**Subject:** Additional Submission to SNPP and additional documents from applicant's arborist – DA2021/1912 and DA2021/1914

**Ref:** 2023/319791

This memo is in response to a further late submission received regarding DA2021/1912 and DA2021/1914. This memo also addresses additional documentation provided by the application that clarifies the extent of tree removal for DA2021/1914 which was a query raised by the NBLPP in their consideration of DA2021/1914 (the subdivision application).

Figure 1 - Extract of proposed subdivision plan for DA2021/1912 showing 4.5m wide right of way

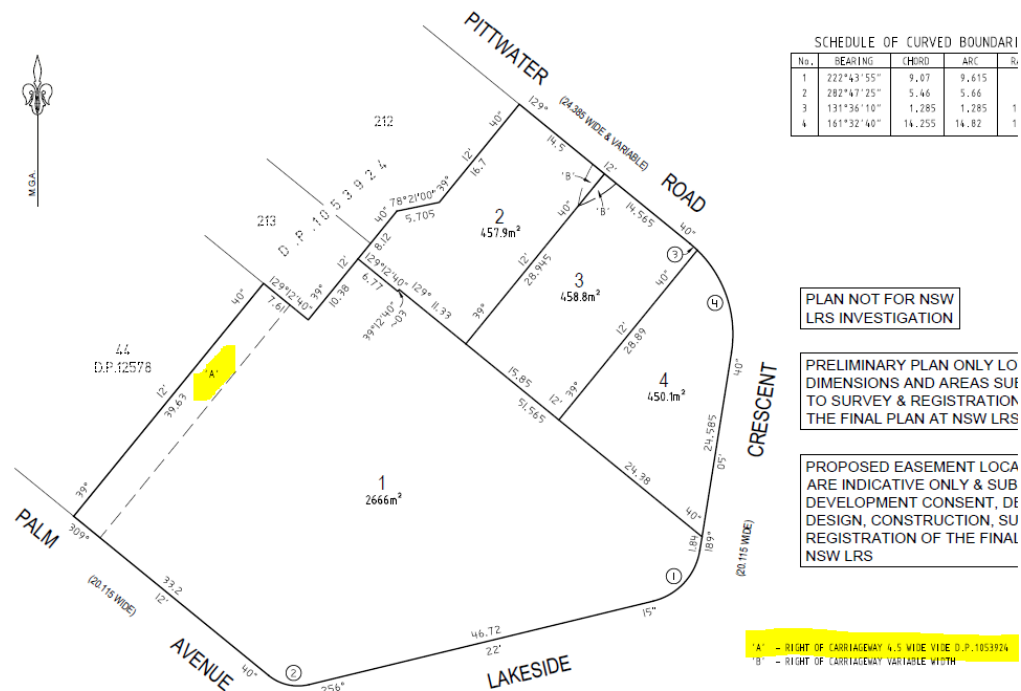
- 1. The common roadway to be used by 8A Palm Avenue and by the new residents in the proposed car park in Lot 1 must be a 5.5m wide two-way carriageway thorough to my clients' property. The existing scaled driveway width of approximately 4.8m is insufficient to allow two vehicles to safely pass and there is concern that this may lead to vehicles reversing back onto Palm Avenue to allow an opposing vehicle to pass. There are six disabled car spaces shown on Lot 1 carpark, raising additional concerns. A passing bay solution is considered inappropriate considering visitors would not be aware of that type of provision, leading to further unsafe outcomes;*

- 2. There is no pedestrian footpath to the western boundary shown to provide safe access from Palm Avenue to my Clients boundary at 8A Palm Avenue – pedestrians, including children and the elderly, would be required to walk on the roadway that already is too narrow.*

The adjoining property 8A Palm Avenue gains access off Palm Avenue via a 4.5m wide right-of-way through the south-western lot of the subject development site (Lot 45 DP 12578, 8 Palm Avenue). The right-of-way is described in DP1053924 and is marked as

(E) right-of-way 4.5m wide. The submission raises concern with changes to the driveway width, landscaping and pedestrian access contained within the right-of-way providing access to 8A Palm Avenue. These changes within the right-of-way are proposed in association with DA2021/1912 for the adaptive re-use of the Queenscliff Community Health Centre building (for which Council's recommendation to the SNPP is refusal).

The plans submitted with DA2021/1912 shows that the existing carpark and driveway is proposed to be demolished and reconstructed as part of the development. The proposed driveway to be re-constructed sits within the right-of-way. The driveway is proposed to have a 3m wide pavement plus landscape strip adjoining the western boundary of the site. The driveway is proposed to have a 6m x 6m passing bay. See

Council's traffic engineer has considered the proposed access arrangement within their referral response (see page 21 of the assessment report for DA2021/1912) and following the additional information received from the applicant's traffic engineer dated 16 September 2022 prepared by Colston Budd Rogers & Kafes, Council's traffic engineer has indicated they are satisfied with the proposed access arrangement for the site. Council's traffic engineer has not raised any concern with pedestrian access to 8A Palm Avenue and it is noted that there is no existing separate pedestrian pathway within the right of way.

To avoid any ambiguity between the works consented to under DA2021/1914, it is recommended the SNPP include the following if consent is granted to DA2021/1914:

*This application does not grant consent to any changes to the existing carpark or changes to the access driveway within proposed Lot 1 or any works within the existing right of carriageway within proposed Lot 1.*
